U. S. Nuclear Regulatory Commission
ATTN: Document Control Desk
Washington, DC 20555-0001Three Mile Island Nuclear Station, Unit 1
Facility Operating License No. DPR-50
NRC Docket No. 50-289

Subject: License Amendment Request No. 326 to Adopt TSTF-490-A, Revision 0, "Deletion of E Bar Definition and Revision to Reactor Coolant System Specific Activity Technical Specification Using the Consolidated Line Item Improvement Process"

ATTACHMENT 1

ATTACHMENT 2

FIGURE 3.1-2a

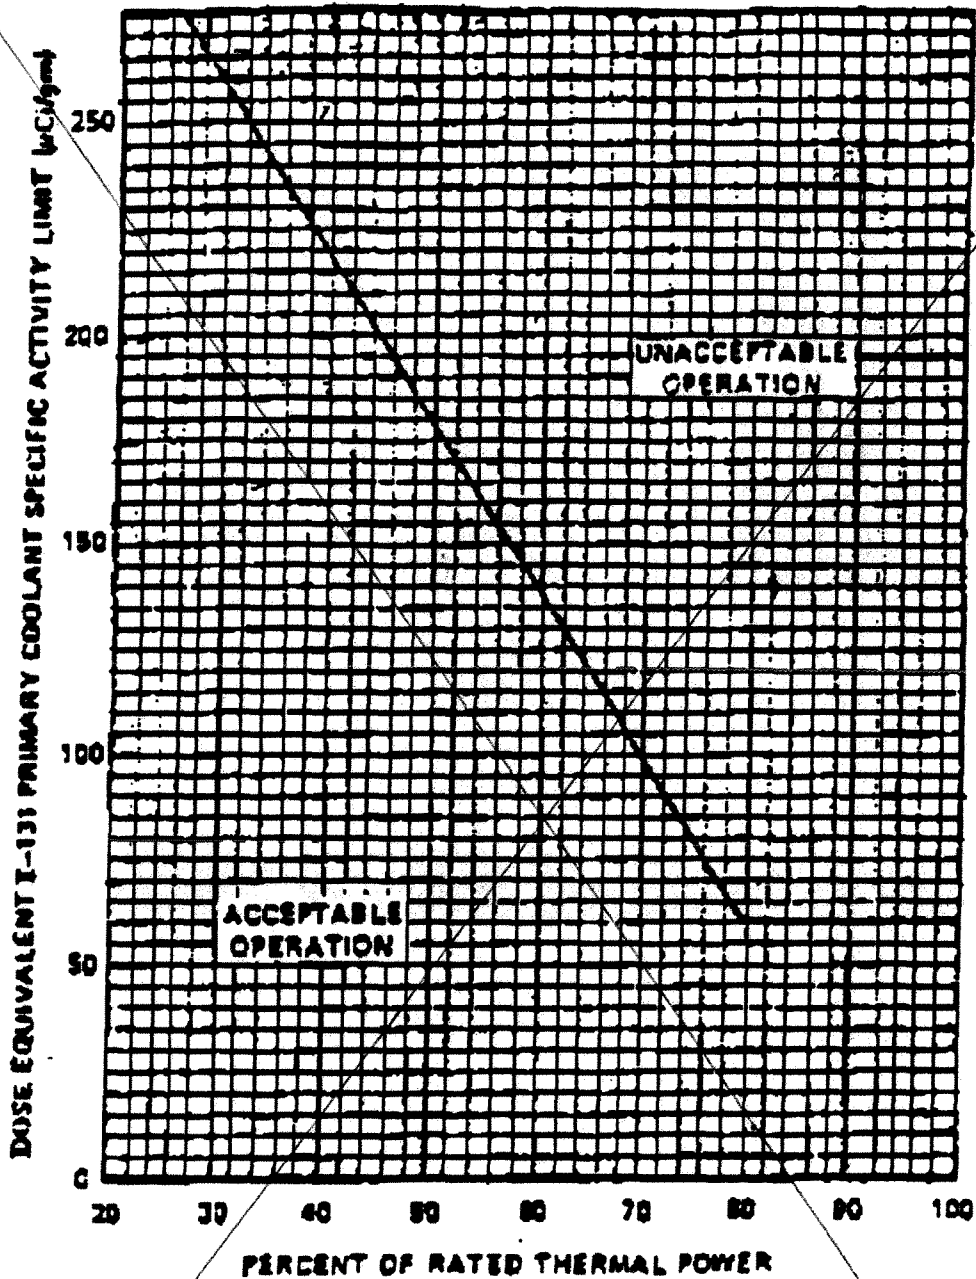
- Delete Figure 3.1-2a, "Reactor Coolant DOSE EQUIVALENT I-131 Specific Activity Limit versus Percent of RATED THERMAL POWER."
- Revise LCO 3.1.4.2 "Applicability" to specify the LCO is applicable in all modes with the exception of REFUELING and COLD SHUTDOWN.

- Modify ACTIONS 3.1.4.3 as follows:
 - A. Condition A is modified to delete the reference to Figure 3.1-2a, and define an upper limit that is applicable at all power levels.

- The deletion of Figure 3.1-2a, "Reactor Coolant DOSE EQUIVALENT I-131 Specific Activity Limit versus Percent of RATED THERMAL POWER" in the TS requires deletion of the figure title in the "List of Figures" on TS page vii, and the insertion of the word "DELETED" to note the change. This change meets the original intent of TSTF 490-A, Revision 0.
